**Recall Campaign**  
**Replace crankshaft position sensor**  
**Models 164, 211 and 221 with engine OM642**  
**Accounting No. 1593034.**

## WORK DESCRIPTION FOR SERVICE MEASURE

### Replace crankshaft position sensor

Model 211; 221; 164 with OM 642

Figure 1

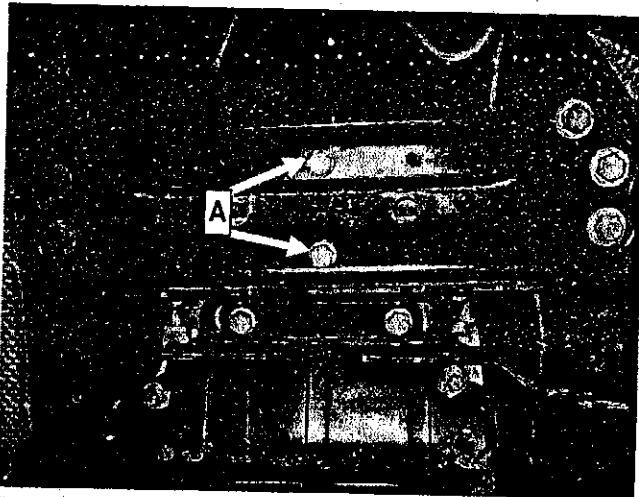
- Remove coolant hose at firewall.
- Remove bracket of rear soundproofing.
- Loosen bolts (A) at crossbar from rear engine mount to transmission (**Nm** 50; figure 1).
